BVH: BP Towers

System: **Schüco USC 65.HI**

Version: V02

Notes – Unitised Façade | V02 (04.09.2026)

Transom 9669043

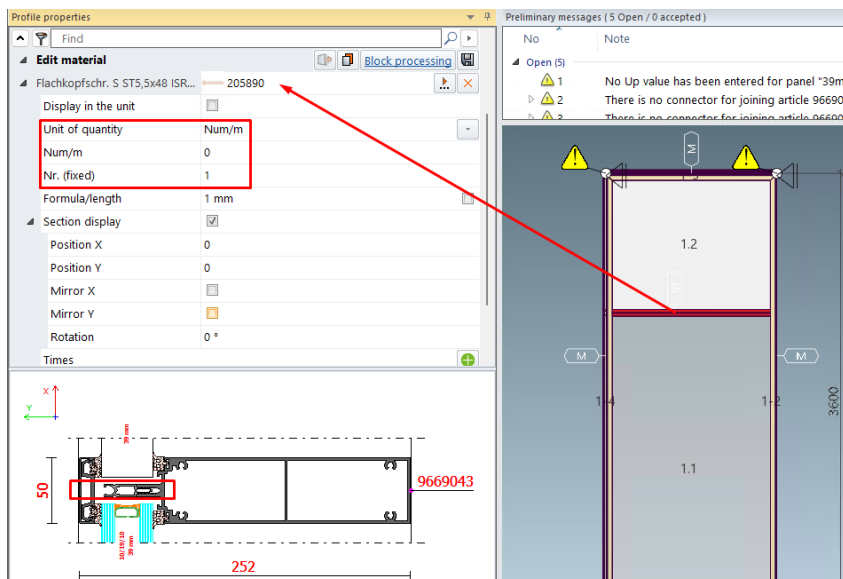
for glazing bead – “Dummy_Cover” has to be used (can be deleted), cover profil will be taken automatically (glass 39mm)

Screw 205890 – number has to be changed manually (number/m)

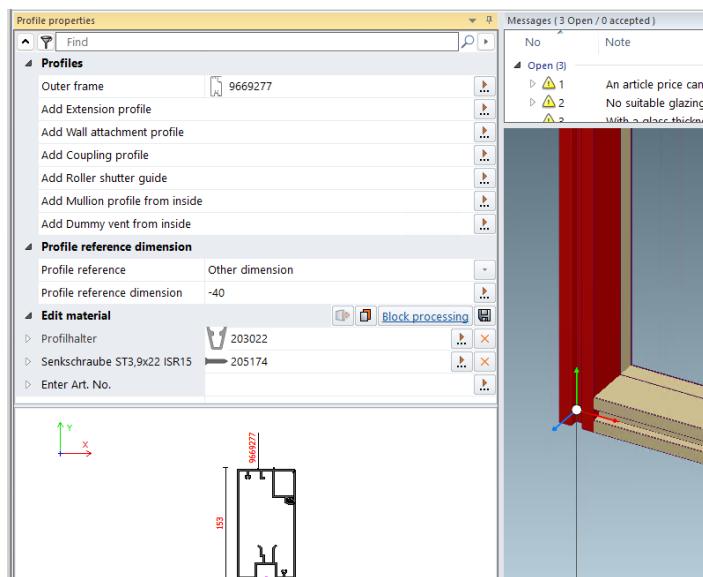
- **General information:**
 - 3 element types – 150mm / 300mm / 450mm
 - System: Schüco AWS/ADS 50.NI
 - Not uses profile have to be deactivated (function “delete/restore profiles”)
 - Additional Material (screws etc.) have to be added manually
- **Element 150mm / 300mm**
 - Outer frame = 9669277 / 9669278
 - Intersections have to be adapted:

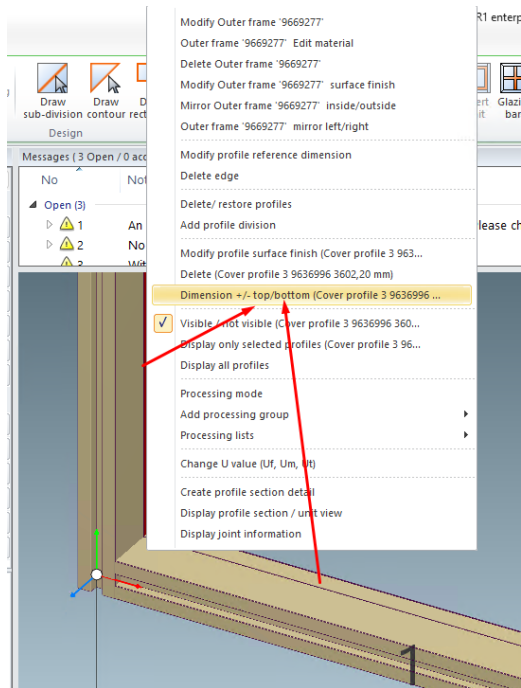
- Number of 203022 and 205174 have to be adapted

■ Element 450mm

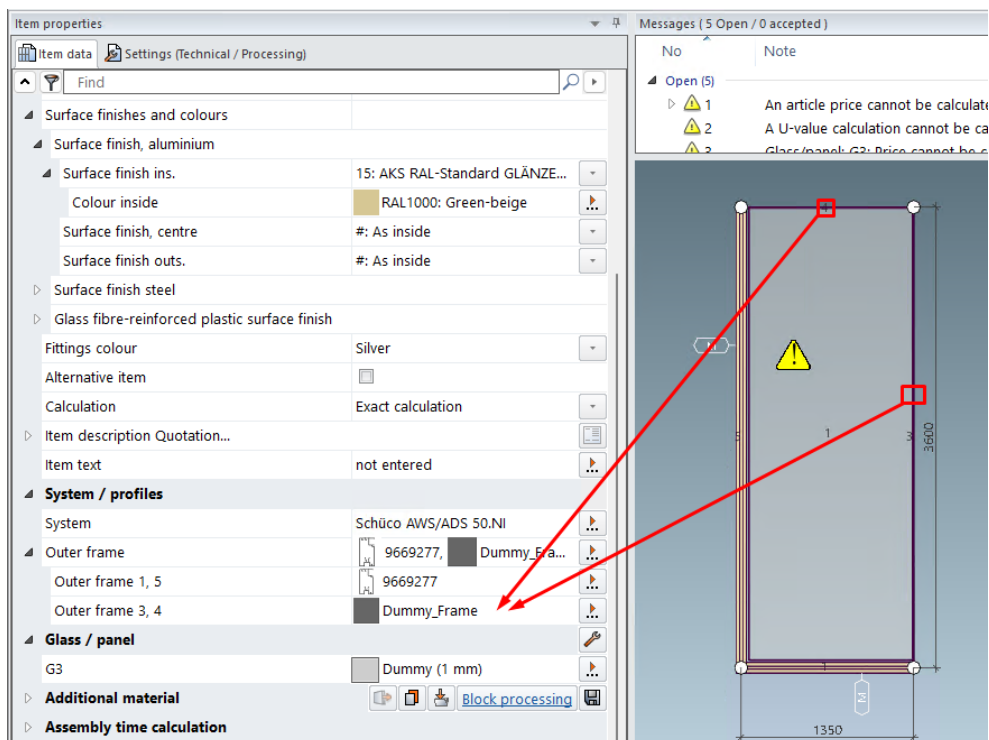
- Outer frame = 9669277
- Glazing = 1mm (dummy glass)
- For part of element, where no profile should be: outer frame = Dummy_Frame

- Other adaptations = same like for element type 150mm and 300mm

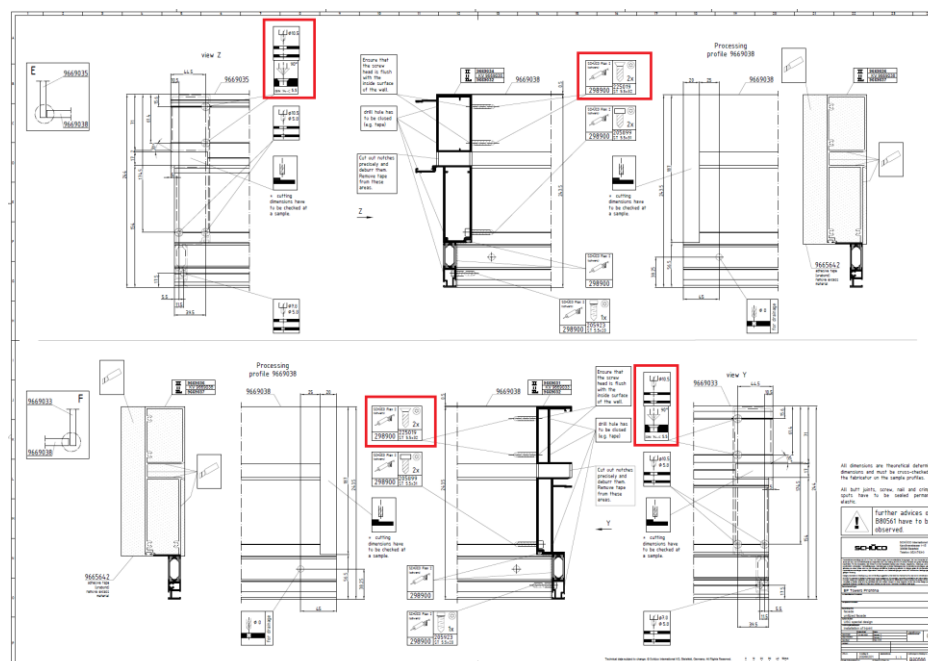
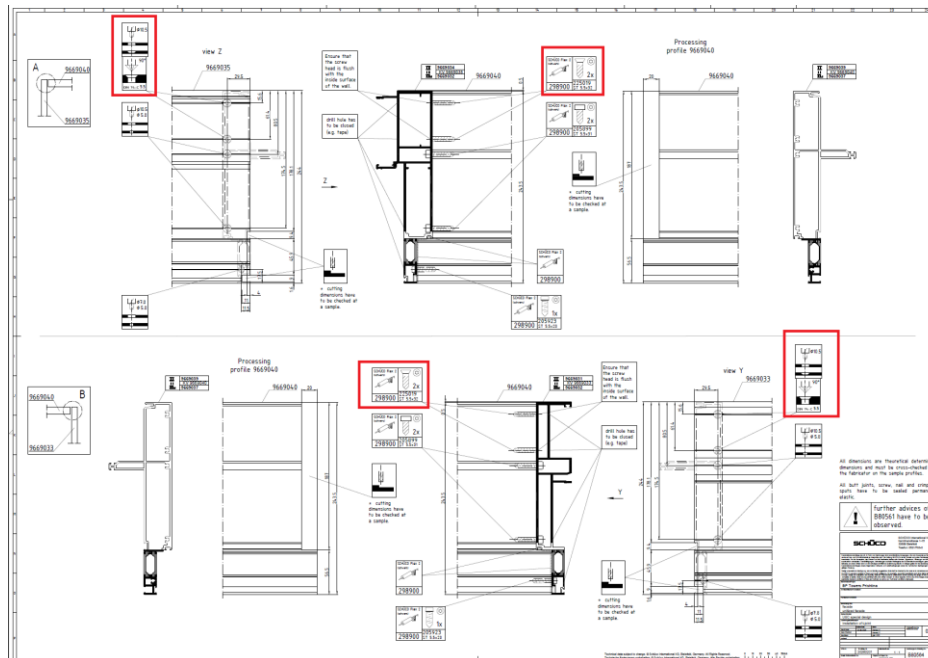
- **Frame-Profiles 9669033, 9669035, 9669038, 9669040**
 - Insulation bar changed from 224085 (PA) to 224084 (PT), according to the B-drawings
- **T-Connection 9669038 + 9669033/9669035 (bottom) and 9669040 + 9669033/9669035**
 - Changes of screws according to the adaptations of drawings B80564_0201 and B80566_0302
 - MCO-processings have to be adapted by the fabricator – according to his machine and tools
